Access Compliance Report

Public Rights-of-Way

(Pedestrian Signals)

Intersection ID: N/A	Main Street:	Cross Street: N/A	Location: N/A
ADA ID: 49C88C643526	Signal Type: Two Push Buttons-Non APS	Overall Compliance: No	Severity Score: BTN 1:N/A BTN 2: N/A No BTN: N/A
Codes/Mitigation Info/Possible Solution		Field Measurements/Component Compliance

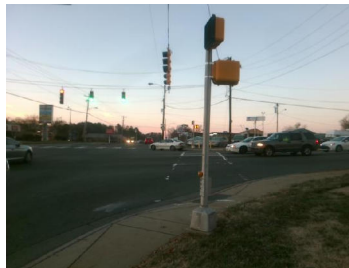
PROW/ADA: TMUTCD 4e.08, R404.3, R406.2, R404.2

Compliance	Description	Data	Compliance	Description	Data
	Button Count	Button2	N/A	Distant to Additional Button (in)	N/A
	Additional Button Present?	No		Additional Button ID	N/A
N/A	Signal Buttons Required?	N/A	N/A	Additional Ped Posts Required	N/A
	How Many Ped Street Xings?	2		Located In An Island/Median?	No
N/A	B 1 Sign Present?	Yes	N/A	B 2 Sign Present?	Yes
Yes	B 1 Sign Purpose?	Yes	Yes	B 2 Sign Purpose?	Yes
Yes	B 1 Sign Lettering & Contrast?	Yes	Yes	B 2 Sign Lettering & Contrast?	Yes
Yes	B 1 Parallel To XWalk?	Yes	Yes	B 2 Parallel To XWalk?	Yes
No	B 1 PAR to Button?	No	No	B 2 PAR to Button?	No
No	B 1 PAR to XWalk?	No	No	B 2 PAR to XWalk?	No
Yes	B 1 Clear Floor Space?	Yes	Yes	B 2 Clear Floor Space?	Yes
N/A	B 1 FWD Approach?	Yes	N/A	B 2 FWD Approach?	Yes
N/A	B 1 FWD Approach Constrained?	No	N/A	B 2 FWD Approach Constrained?	No
No	B 1 FWD Approach Reach (in)	13.0	No	B 2 FWD Approach Reach (in)	11.0
N/A	B 1 FWD Approach Width (in)	N/A	N/A	B 2 FWD Approach Width (in)	N/A

N/A	B 1 FWD Approach Obstruction?	Yes	N/A	B 2 FWD Approach Obstruction?	Yes
N/A	B 1 FWD Approach Obstruction Dist (in)	2.0	N/A	B 2 FWD Approach ObstructionDist (in)	2.0
N/A	B 1 PARA Approach?	Yes	N/A	B 2 PARA Approach?	Yes
N/A	B 1 PARA Approach Constrained?	No	N/A	B 2 PARA Approach Constrained?	No
Yes	B 1 PARA Approach Reach (in)	7.0	Yes	B 2 PARA Approach Reach (in)	7.0
N/A	B 1 PARA Approach Width (in)	N/A	N/A	B 2 PARA Approach Width (in)	N/A
N/A	B 1 PARA Approach Obstruction?	Yes	N/A	B 2 PARA Approach Obstruction?	Yes
N/A	B 1 PARA Approach Obstruction Dist (in)	1.0	N/A	B 2 PARA Approach ObstructionDist (in)	1.0
Yes	B 1 Clear Floor Space Slope (%)	4.9	No	B 2 Clear Floor Space Slope (%)	4.9
Yes	B 1 Clear Floor Space XSlope (%)	1.5	Yes	B 2 Clear Floor Space XSlope (%)	1.9
N/A	B 1 PAR Slope (%)	11.5	N/A	B 2 PAR Slope (%)	3.8
Yes	B 1 Height (in)	40.0	Yes	B 2 Height (in)	40.0
Yes	B 1 Pressure (#)	3.0	Yes	B 2 Pressure (#)	3.0

Yes	B 1 Clear Xing Direction?	ClearlyMarked	Yes	B 2 Clear Xing Direction?	ClearlyMarked
	B 1 Crossing Direction	To SW		B 2 Crossing Direction	To SE
Yes	B 1 DistanceTo XWalk (in)	0.0	Yes	B 2 DistanceTo XWalk (in)	0.0
No	B 1 DistanceTo Curb (in)	75.0	No	B 2 DistanceTo Curb (in)	75.0
Yes	B 1 Diameter (in)	2.0	Yes	B 2 Diameter (in)	2.0

Possible Solutions: Replace Signal Push Button With APS Button on New Post. Remove & Relocate Sign.
